STAFF REPORT & RECOMMENDATION
Port of Woodland
Guild Road Industrial Park Phase I

ISSUE DATE: December 28, 2018

Land Use Application No.: SPR2018-004/CAP2018-001

C:\Users\annac\AppData\Local\Temp\AcrPublish_10512\PWL02_13-17 - Planting Plan.dwg

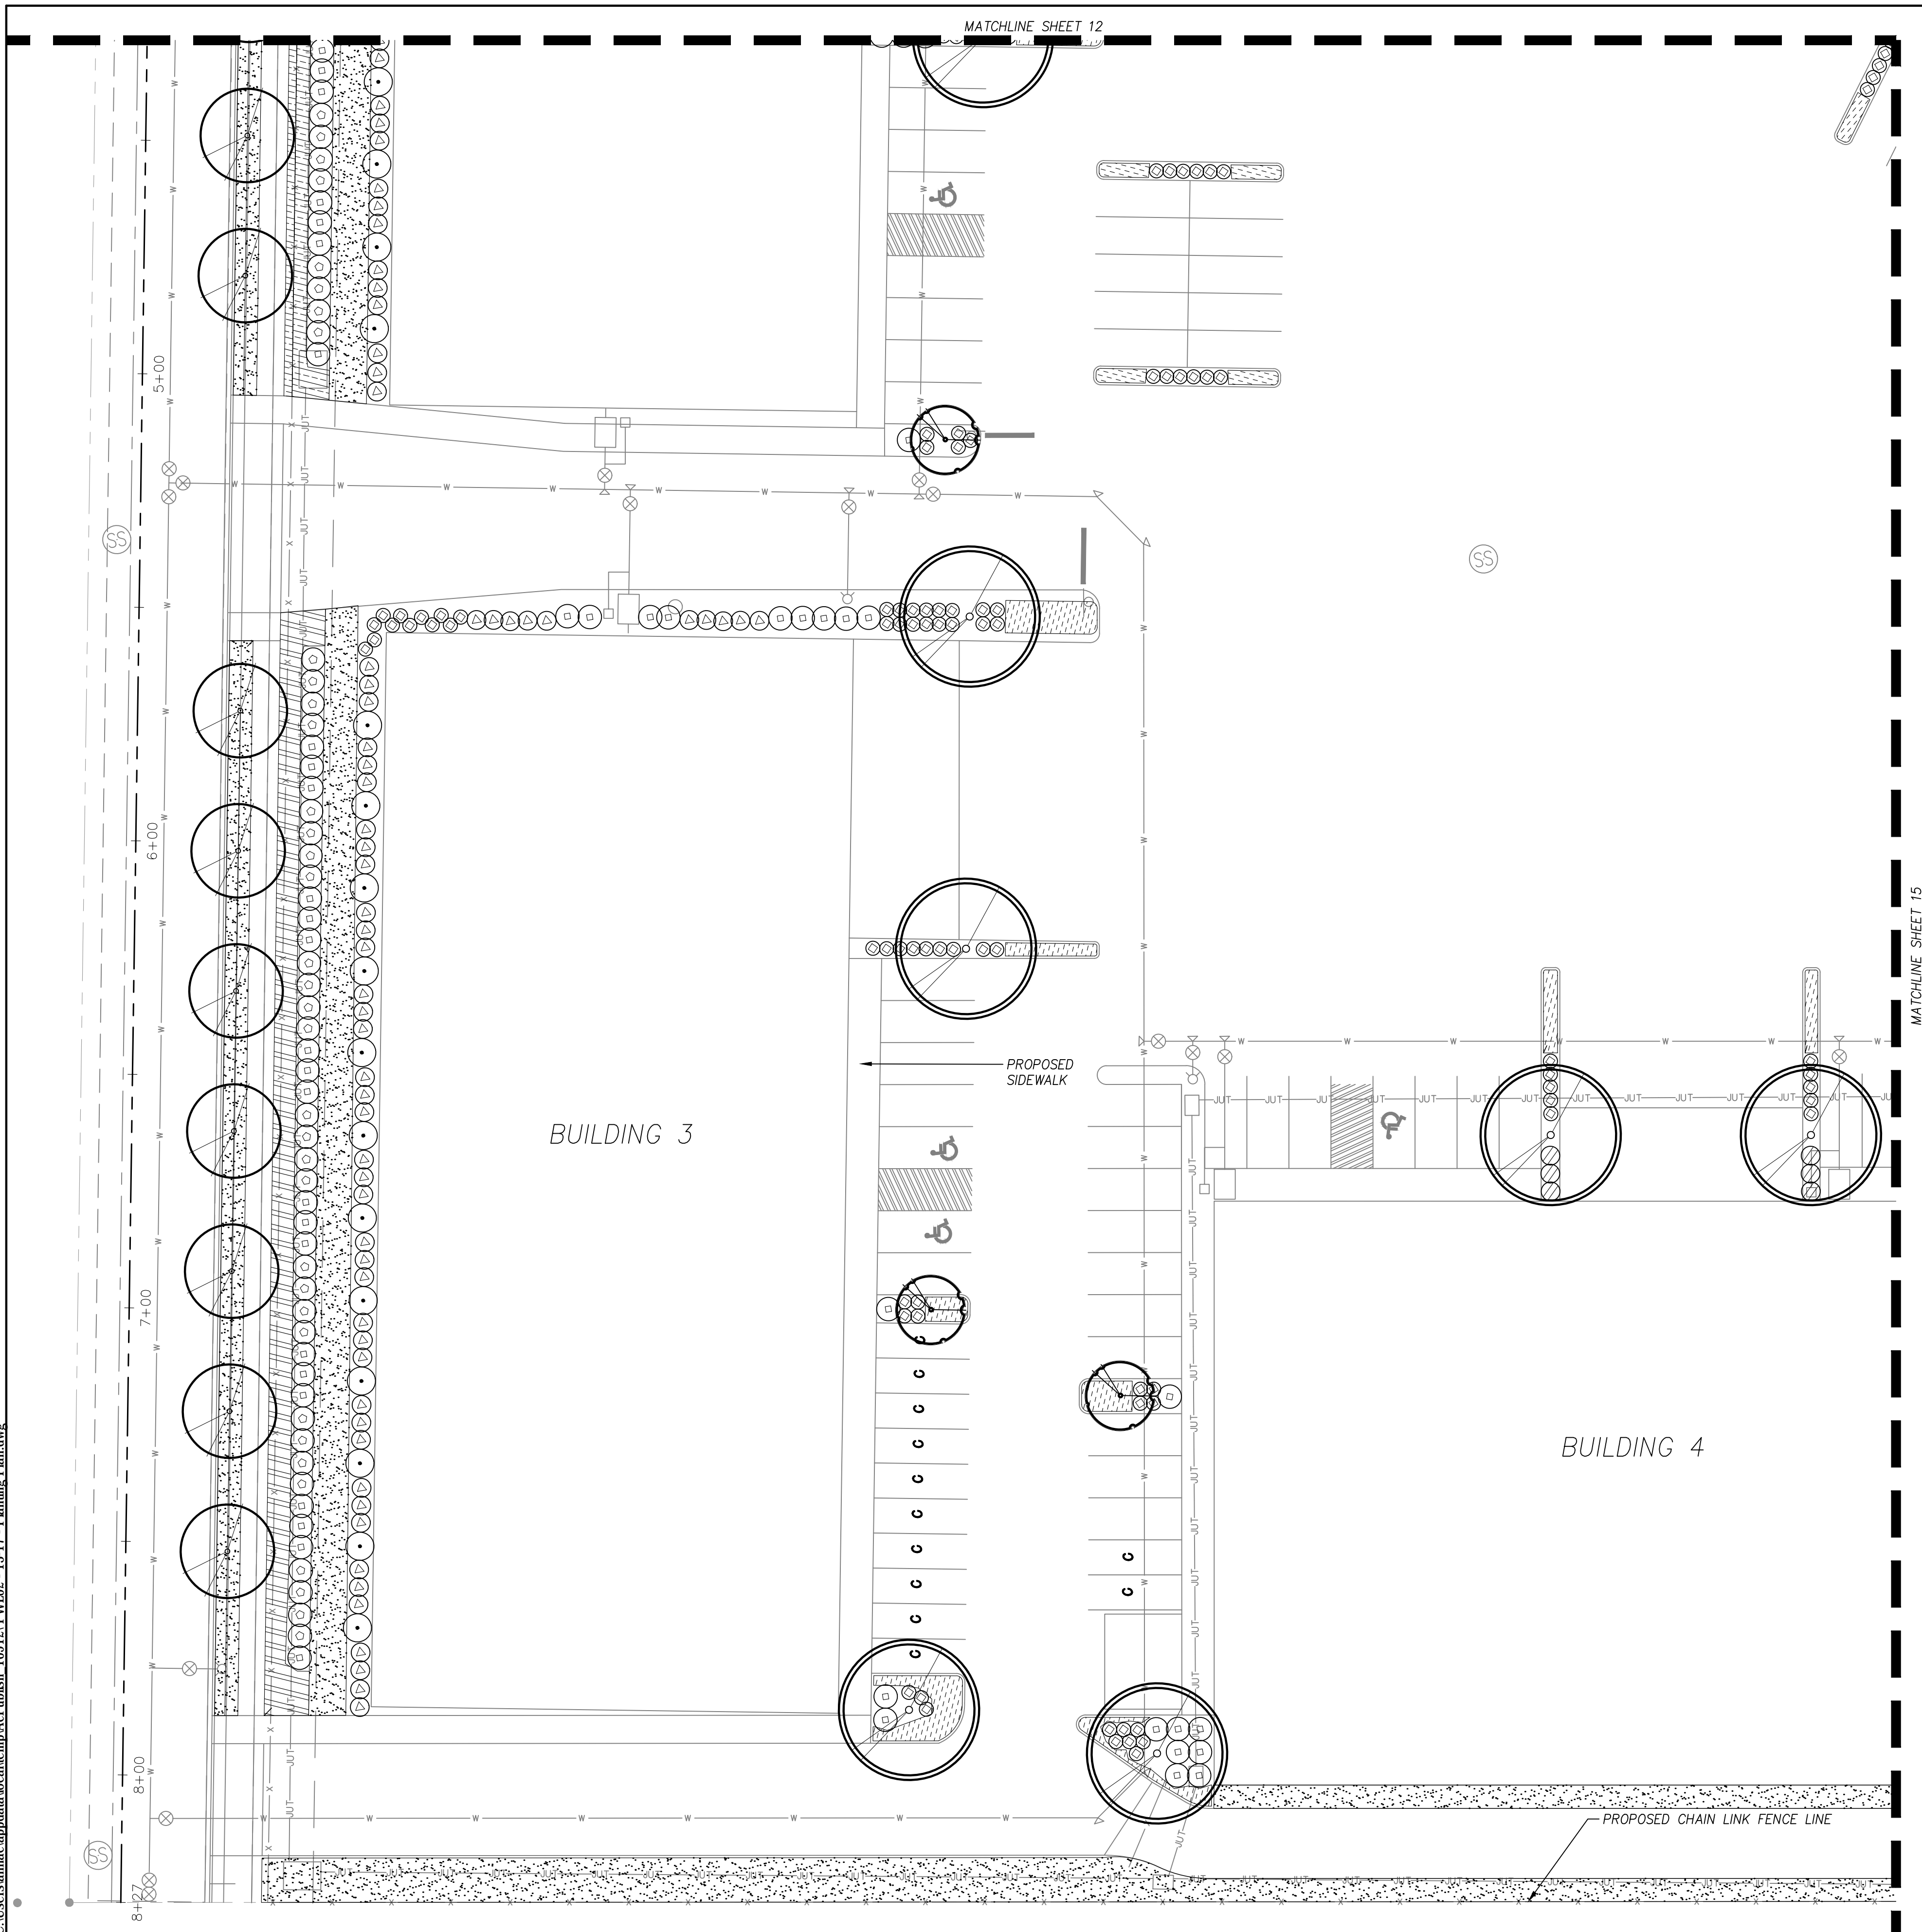
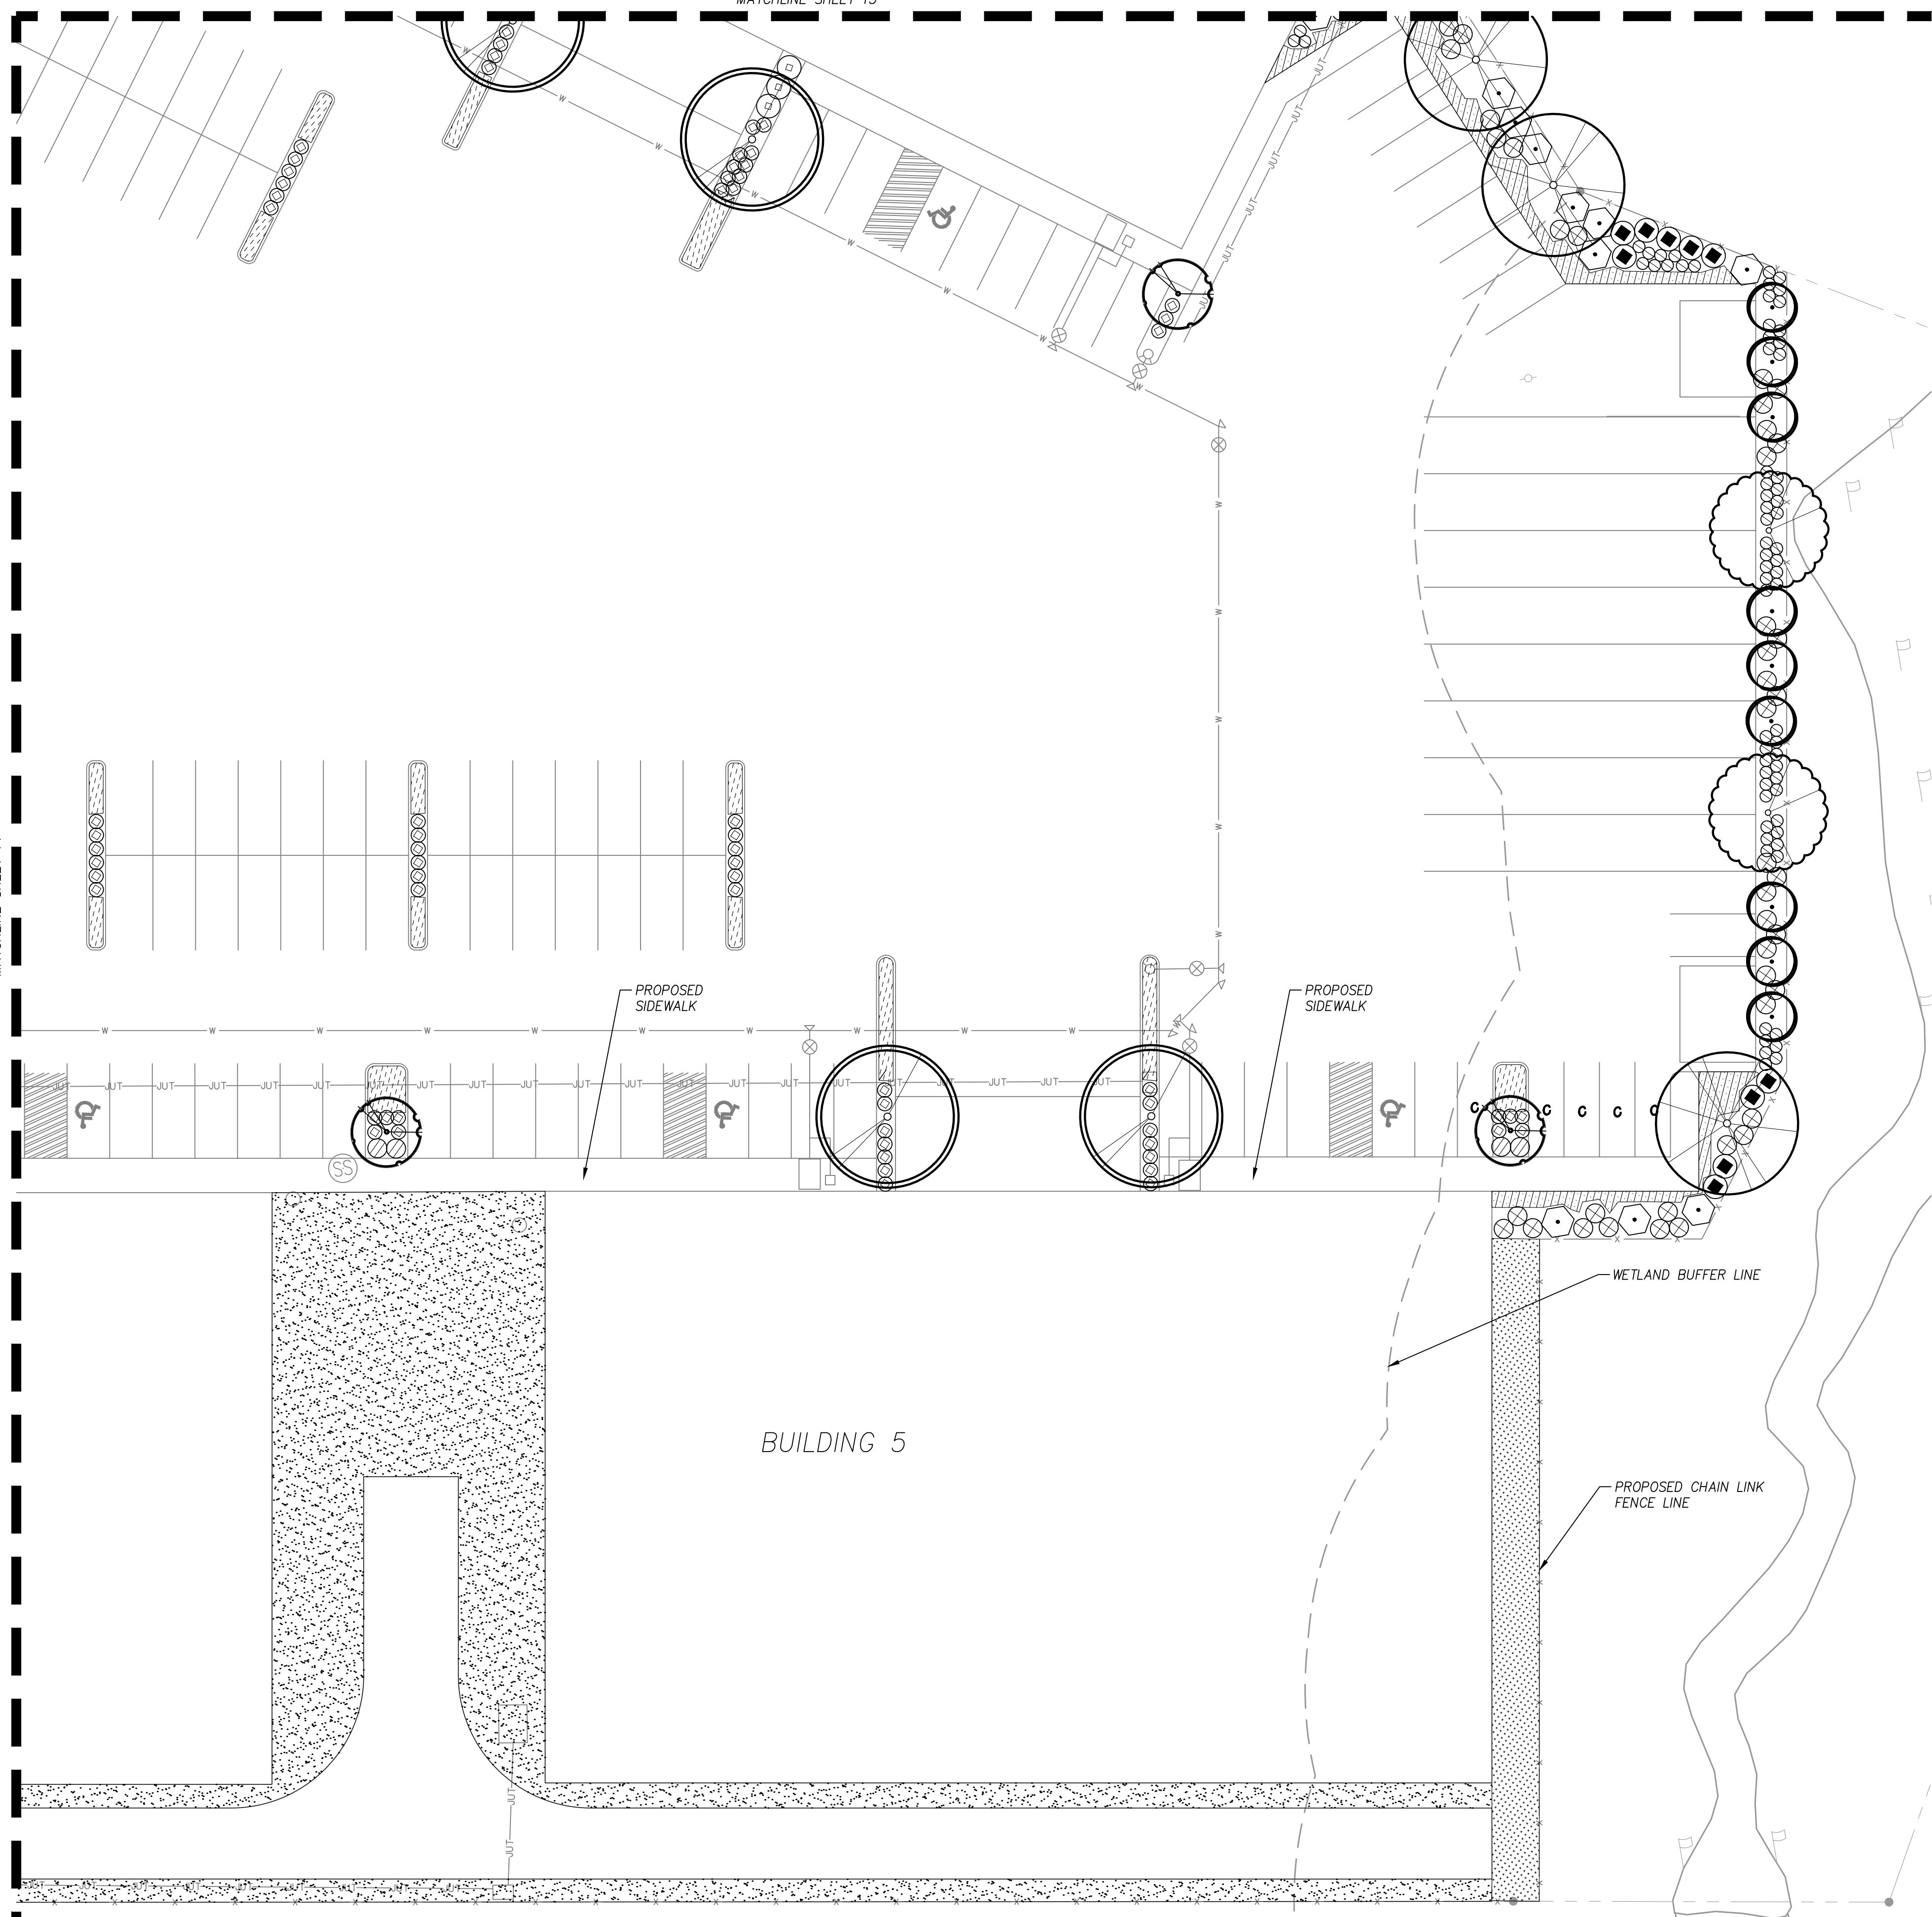
Finding 12: The applicant has submitted the landscaping plan material with the application material as required by WMC 17.44.133 and .134. except it was not stamped and signed by a qualified professional.

Finding 13: The proposed master landscaping plan appears to comply with the standard of WMC 17.44.135 in terms of: landscaping materials; shrub sizing and spacing; tree size and spacing; and non-plant ground covers. For additional comments see below. Implementation of the landscaping will be required prior to occupancy of the first building on the site. (See Site Plan Condition #15)

Finding 18: Landscaping plant selection as shown on the plan includes several species that are not native to the area AND includes some species that can be considered invasive species. Normally, each plant selection includes language that allows for an "approved equal" but this plan does not include that notation. Invasive species should not be included in the planting plan. (See Site Plan Condition #14)

Finding 19: Requirements for Maintenance and Irrigation. The use of drought-tolerant plant species is encouraged and shall be required when irrigation is not available. Irrigation shall be provided for plants that are not drought-tolerant. In this case, note 11 from Page 13 of the plans clearly indicates that irrigation will be provided by others.

14. The master landscape plan shall be modified as necessary to ensure that no invasive species are included in the plantings.
15. Landscaping shall be installed prior to any building on the site being occupied.

1 BUILDING 4 & 5
 19 1/8" = 1'-0"

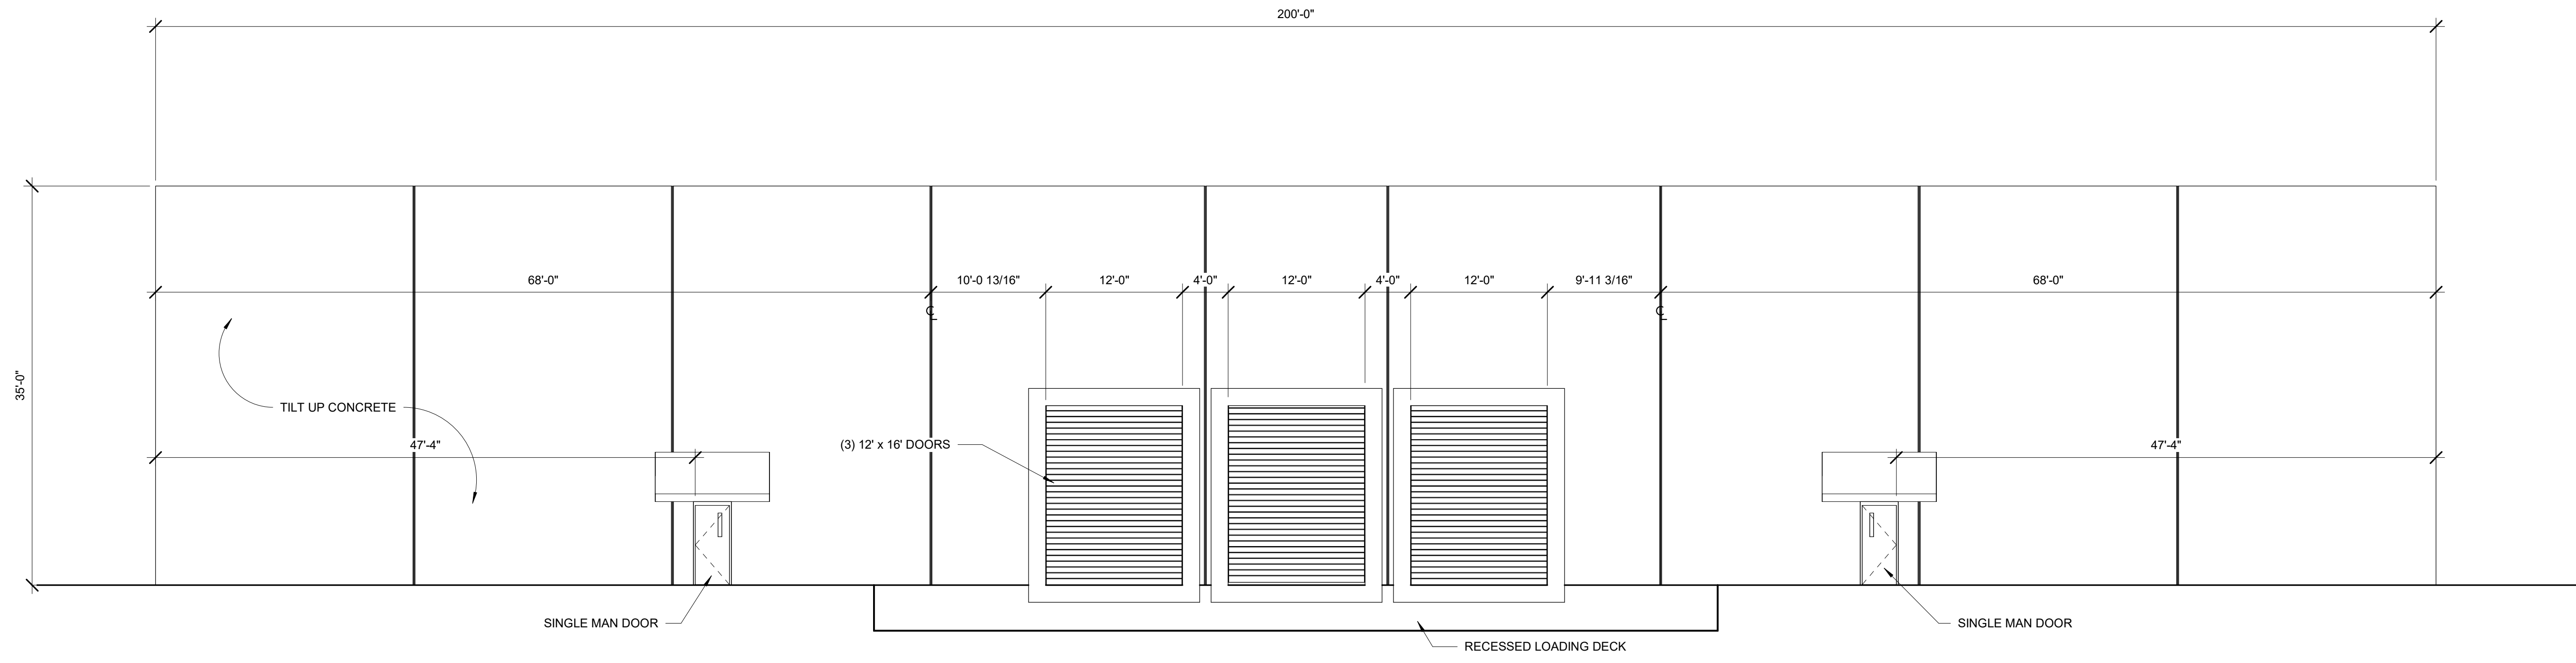
Finding 37: The Fire Department Access on the South Side of Buildings 4 & 5 must be 20’ wide, providing access to within 150’ of any point on the perimeter of the building. (See Site Plan Condition #5)

5. The Fire Department Access on the South Side of Buildings 4 & 5 must be 20' wide, providing access to within 150' of any point on the perimeter of the building.
